## APPENDIX D

### Consultation Record

| <b>Project Title</b> | Pear Tree Solar Farm |

| <b>Meeting Title</b> | Hydraulic Modelling Discussion |

*Figure 1: Locations on the River Hull which intersect the red line boundary for the site where breaches are not proposed.*

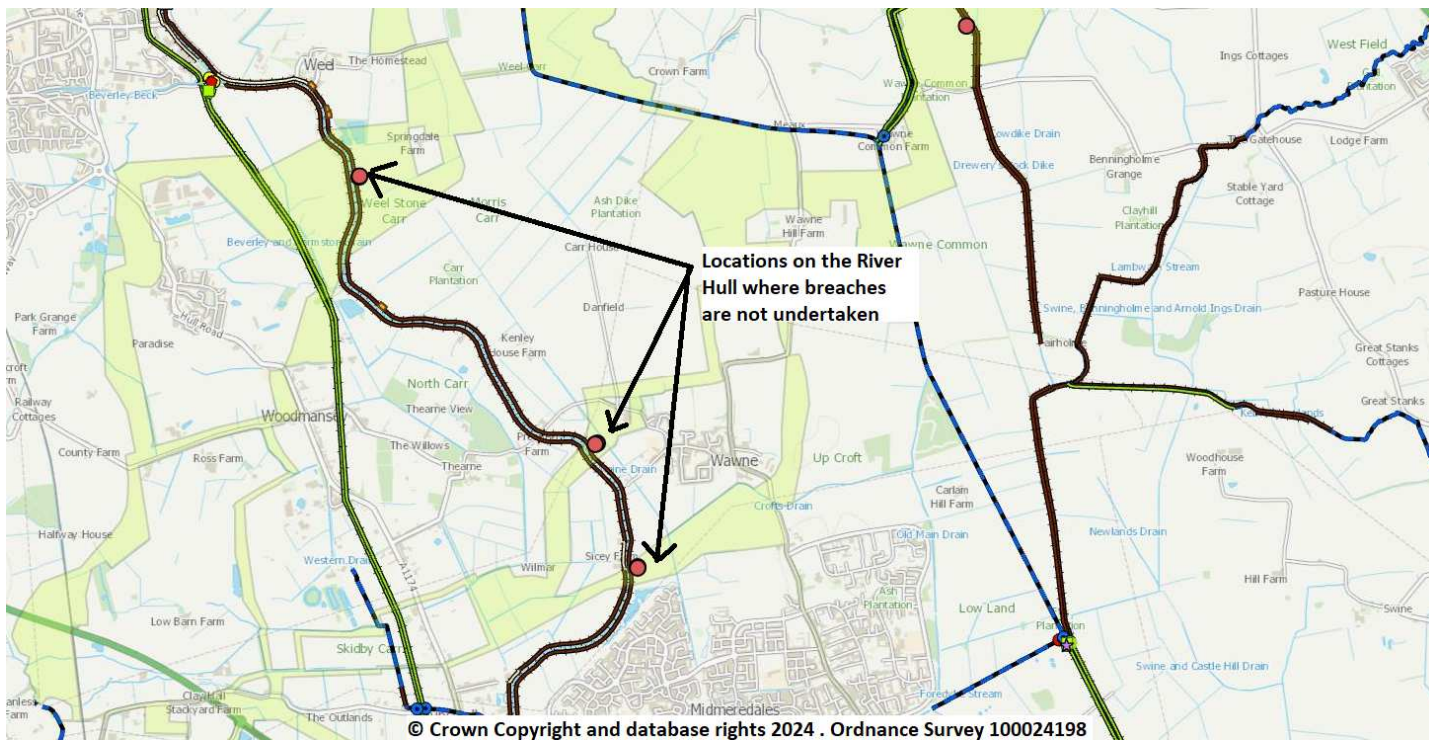
What was the rationale for not undertaking a breach at east 506700 north 438725, east 508280 north 436920, and east 508565 north 436090 on the left and right bank of the River Hull (figure 1 below)? Is this because these are relatively low risk areas for cable routing?
